UNITED STATES PATENT AND TRADEMARK OFFICE

APPLICATION NO.	FILING DATE	FIRST NAMED INVENTOR	ATTORNEY DOCKET NO.	CONFIRMATION NO.
10/587,779	07/28/2006	Gordon Thelwell	5897-000029/US/NP	9918

Office Action Summary	Application No. 10/587,779	Applicant(s) THELWELL, GORDON	
	Examiner Joshua Rodden	Art Unit 3637

DETAILED ACTION

Annotated Figure 2

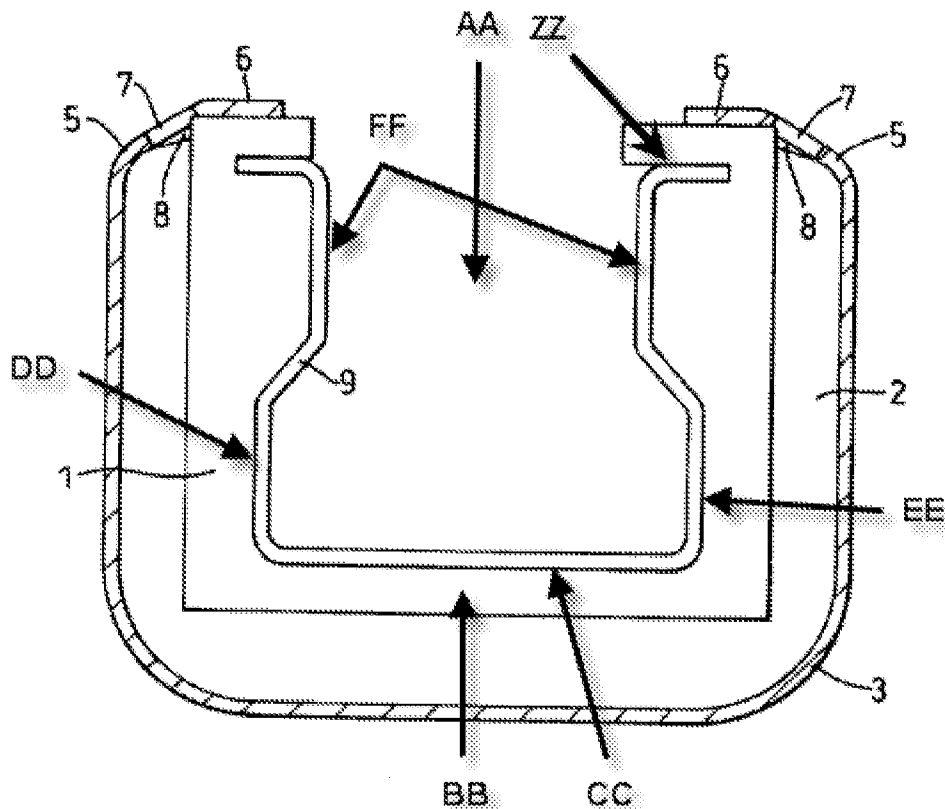
Regarding **Claim 61**, Ian teaches; **Claim 61** - a column protecting device (3) for protection of an upright column (9) of a racking system, (Figure 3); wherein the column (9) has a channel shaped cross section (AA) having a substantially rectangular front portion (BB) consisting of a front member (CC), and a first (DD) and second (EE) side member, (Annotated Figure 2 Below); the column protector device (3) being arranged to clip onto the upright column (9), (Figure 2 and Page 4, Lines 10-14); the protector device further comprises a rigid, substantially part cylindrical “C” shaped cross section outer shell (3), and an inner liner (1 and 2) shaped to fit within the outer shell (3), (Figure 2 and Page 3, Lines 3-8 of the specification); wherein the outer shell (3) is capable of fitting around the upright column so that the outer shell (3) retains to the column (9) without further fixtures, (Figure 2 and Page 4, Lines 10-14); the outer shell

(3) also surrounds the front member (CC) and partially surrounds (does not surround the tips labeled as ZZ) the first (DD) and second (EE) side members, (Annotated Figure 2 Below); the inner liner (1 and 2) being retained between the outer shell (3) and the column (9), (Figure 3); the inner liner (1 and 2) comprises a solid substantially part cylindrical member having a substantially part cylindrical outer surface (the outer corners of (2) are rounded and the inner liner is therefore part cylindrical), the inner liner (1 and 2) also having a substantially “U” shaped channel (the inner surface of the liner (1) touching the upright column (9)) formed on an opposite side of said inner liner to said substantially part cylindrical outer surface and in which, in use, said channel provides for a flush interface between the inner liner (1 and 2) and the upright column (9), (as seen in Figure 2); **Claim 62** – wherein each of the first and second side members (DD and EE) comprises an outer (DD and EE) and an inner side member (FF), (Annotated Figure 2 Below); the outer shell (3) when fitted to the column (9) surrounds the front member (CC) and said first and second side members (DD and EE), thereby protecting them, (Annotated Figure 2); the outer shell (3) partially surrounds the first and second inner side members (FF) so that the exposed upright edges (the end edges near item (6) in Annotated Figure 2) of the outer shell (3) lay adjacent to the sides of the column at a position where the column is relatively narrower, (Annotated Figure 2 Below); **Claim 63** – wherein, in use, the column (9) resides partially within a channel formed by the outer shell (3), (Figure 2); **Claim 64** – wherein said outer shell (3) comprises an elongate member having a substantially “C” shaped cross section, (Figure 2); **Claim 80** – wherein said inner liner (1 and 2) is capable of, after receiving an impact,

the inner liner (1 and 2) promotes the repositioning of the whole device to an original shape before the impact occurred, (Figure 2 and Page 4, Lines 3-8); **Claim 81** - the outer shell (3) surrounding the front member (CC) and partially surrounding (does not surround the tips labeled as ZZ) the first (DD) and second (EE) side members, and also surrounding the inner liner (1 and 2), which rests between a substantially part cylindrical inner surface of the outer shell (3) and an outer face of the front member (CC), an outer face of the first side member (DD) and second side members (EE), (Annotated Figure 2 Below); **Claim 82** - the inner liner and outer shell being slideable with respect to each other along a central axis of the outer shell, (Page 1, Lines 24-28); **Claim 83** - the outer liner and an inner liner being bonded together, (Page 2, Lines 1-5); **Claim 86** - the outer shell and the inner liner composed of polycarbonate and foam (Page 2, Line 8 and Page 2, Lines 6-7); both materials having greater ductility, and impact resilience than the shelving which is made from metal (Page 1, Lines 12-14); **Claim 87** - teaches the device being "capable of" fitting around the upright column so that the outer shell (3) retains to the column (9) without further fixtures, (Figure 2 and Page 4, Lines 10-15).

Annotated Figure 2, Version #2 (lan)

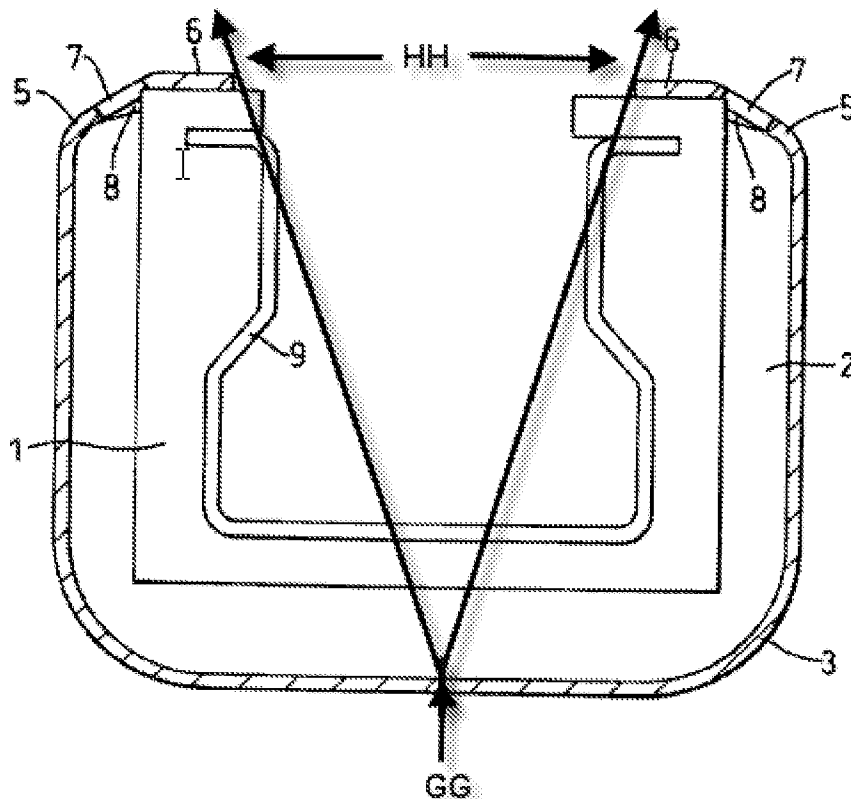
Regarding **Claim 65**, **lan** teaches the outer shell (3) comprising a tubular part cylindrical member (3), (Figure 3); wherein the tube has a pair of substantially parallel opposing edges (the end edges near item (6) in Annotated Figure 2, Version #2 Below) on either side of a gap, (Figure 2). **lan** does not teach the cylindrical member extending over an angle in the range of 260 to 280 degrees, but **lan** does teach a range (HH) about a longitudinal centre line (GG) of the outer shell (3) which is very similar to the claimed range, (Annotated Figure 2, Version #2 Below). Therefore, the examiner points to case law *In Gardner v. TEC Systems, Inc.*, 725 F.2d 1338, 220 USPQ 777 (Fed. Cir. 1984), *cert. denied*, 469 U.S. 830, 225 USPQ 232 (1984). The court found that if the only difference between the prior art device and the claims was a recitation of relative dimensions and a device having those claimed dimensions would not perform differently than the prior art device, the claimed device was not patentably distinct from the prior

art device (See MPEP 2144). It would have been obvious to one of ordinary skill in the art to modify the prior art device of **Ian** to have the cylindrical member extending over an angle in the range of 260 to 280 degrees for the purpose of user design as it would not cause the device to perform differently.

Annotated Figure 4

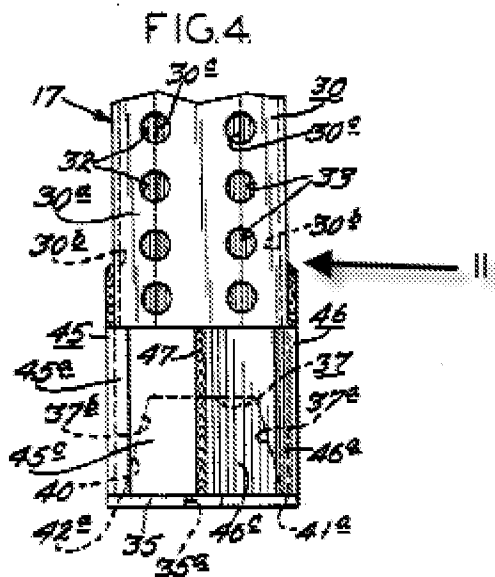
Regarding **Claim 70**, **Ian** teaches the limitations discussed above, but does not teach the outer shell having a chamfered edge. However, **Jacoby et al.** teaches a shell of a protector having a chamfered edge (II) between its outer and inner surface, (Annotated Figure 4 Below). Therefore, it would have been obvious to one of ordinary skill in the art to modify **Ian** to have the outer shell with chamfered edges as taught by **Jacoby et al.** for the purpose of user efficiency and improved protection of the upright column.
